# UNITED STATES PATENT AND TRADEMARK OFFICE

APPLICATION NO.	FILING DATE	FIRST NAMED INVENTOR	ATTORNEY DOCKET NO.	CONFIRMATION NO.
10/626,254	07/23/2003	Sebastien Vergnat	034299-531	1025

<b>Office Action Summary</b>	Application No. 10/626,254	Applicant(s) VERGNAT ET AL. 	
	Examiner Scott Bauer	Art Unit 2836

## **DETAILED ACTION**

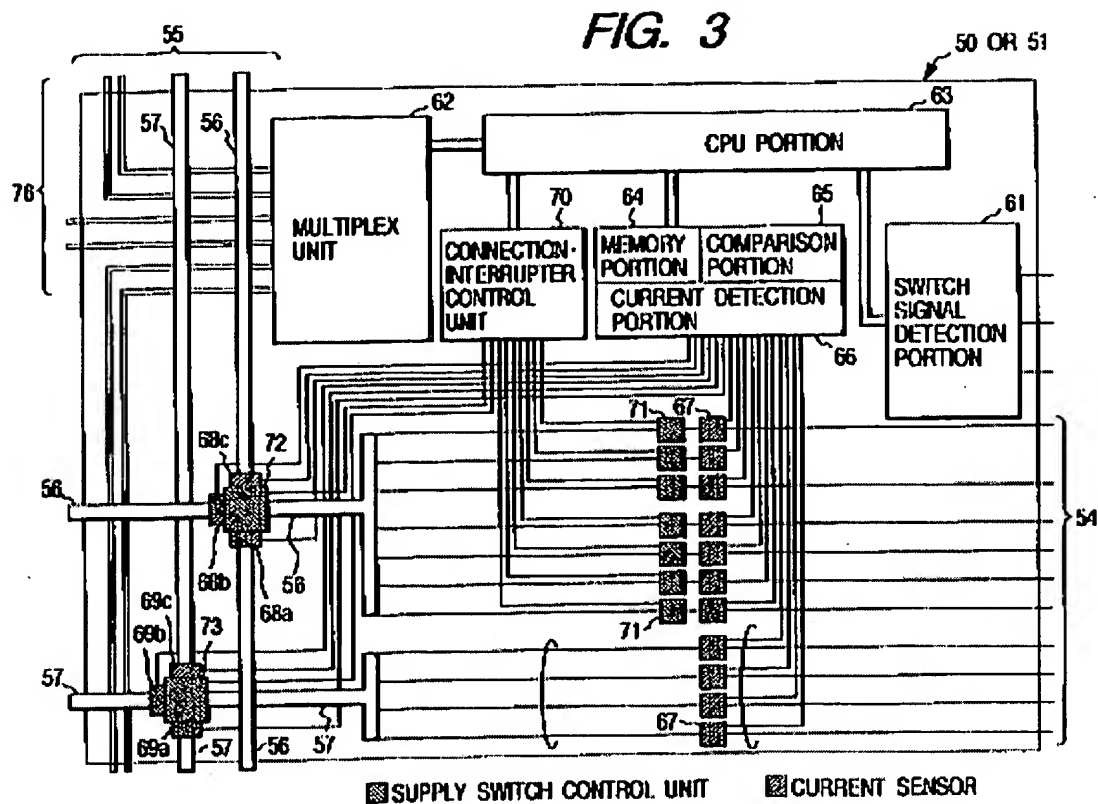
1. Figure 1 should be designated by a legend such as --Prior Art-- because only that which is old is illustrated. See MPEP § 608.02(g). Corrected drawings in compliance with 37 CFR 1.121(d) are required in reply to the Office action to avoid abandonment of the application. The replacement sheet(s) should be labeled "Replacement Sheet" in the page header (as per 37 CFR 1.84(c)) so as not to obstruct any portion of the drawing figures. If the changes are not accepted by the examiner, the applicant will be notified and informed of any required corrective action in the next Office action. The objection to the drawings will not be held in abeyance.

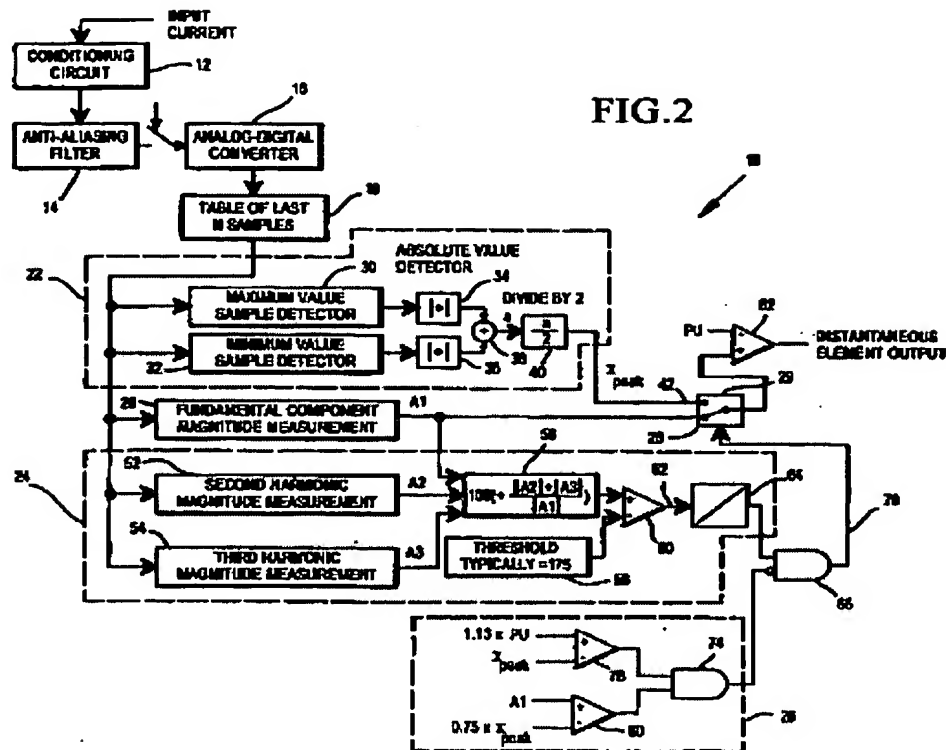
4. With respect to Claim 1, Matsumaru et al. in Figure 3, discloses a device for protection against over-currents in an electrical energy distribution cabinet (50), which receives electrical energy supplied by at least one generator (47) and which distributes this energy to at least two loads connected to 54, which comprises: switching means (70-72), means for calculating (66) the absolute value of the difference between at least one current entering the cabinet and at least one corresponding current leaving the said cabinet, for at least one harmonic of these currents (66, 67, 68a,b,c & 69a,b,c), comparison means (65) which control the opening of the switching means if this absolute value is greater

than a predetermined threshold (61, 65 & 70). This comparison between the current values would inherently require a predetermined threshold.

10. With respect to Claim 3, Matsumaru et al. teaches the invention set forth above and further teaches that the calculating means determining the difference between the current coming from a generator and entering the cabinet and the sum of the currents leaving this cabinet corresponding to the loads supplied by this generator (Fig. 3, 66-69).

11. With respect to Claim 4, Matsumaru et al. teaches the invention set forth above and further teaches that the second calculating means (65) determining the difference between the set of currents entering the cabinet and the set of currents leaving the cabinet (Fig 3. 65).

FIG. 2

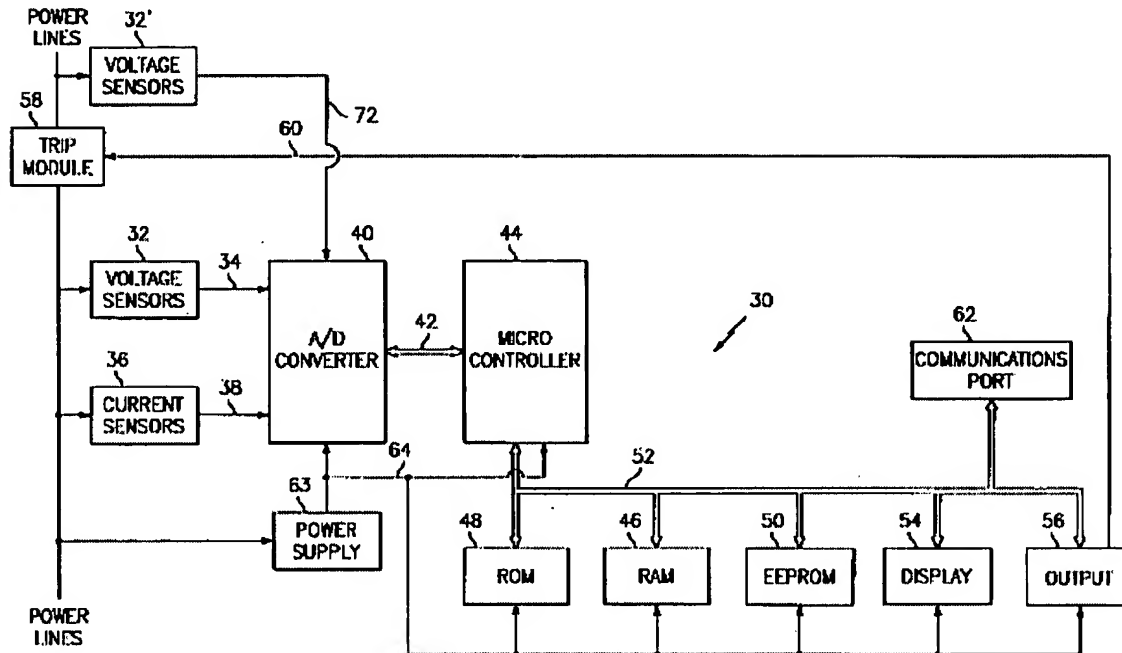
Matsumaru et al. lacks performing the calculation on a harmonic of each of the currents. Benmouyal et al., in Figure 2 teaches a circuit which divides an ac current into its various harmonics in order to determine an over-current condition in a power system (Fig. 2 20, 52 & 54).

Matsumaru et al. lacks performing the calculation on a harmonic of each of the currents. Benmouyal et al., in Figure 2 teaches a circuit which divides an ac current into its various harmonics in order to determine an over-current condition in a power system (Fig. 2 20, 52 & 54).
